Errata to the MPC8272 PowerQUICC II Family Reference Manual, Rev. 2

This errata document describes corrections to the *MPC8272 PowerQUICC II Family Reference Manual*, Revision 2. For convenience, the section number and page number of the errata item in the reference manual are provided. Items with section and page numbers in bold are new since the last revision of this document.

Document Number: MPC8272RMAD
Rev. 2.8
09/2013

Figure 9-1. PCI Bridge in the MPC8272

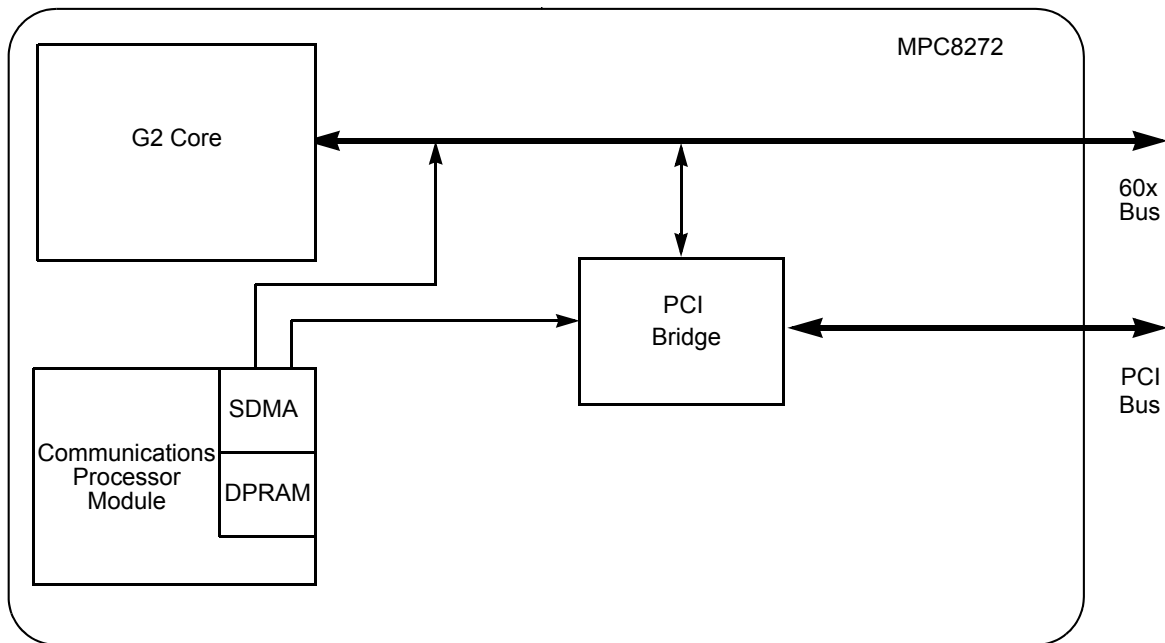
Chapter 9, 9-2

Updated Figure 9-1, “PCI Bridge in the MPC8272,” as follows:

Figure 37-22. Primary and Secondary Programming

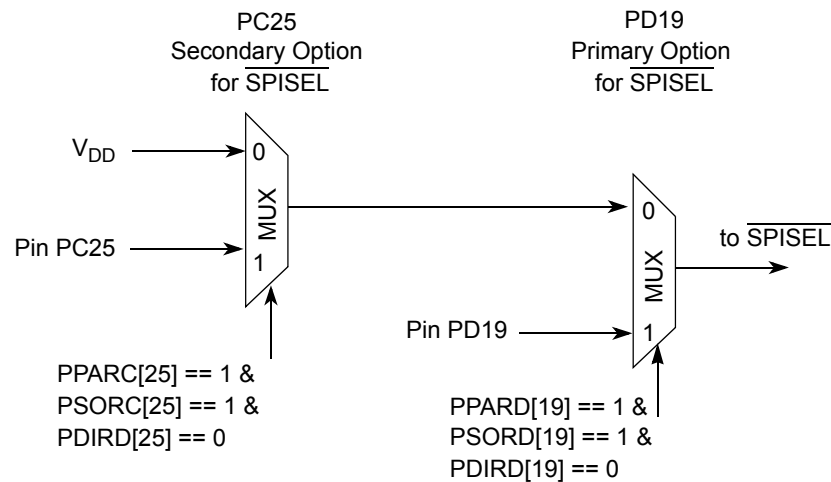
37.5, 37-19

Figure 37-22, “Primary and Secondary Option Programming,” replace with the following:
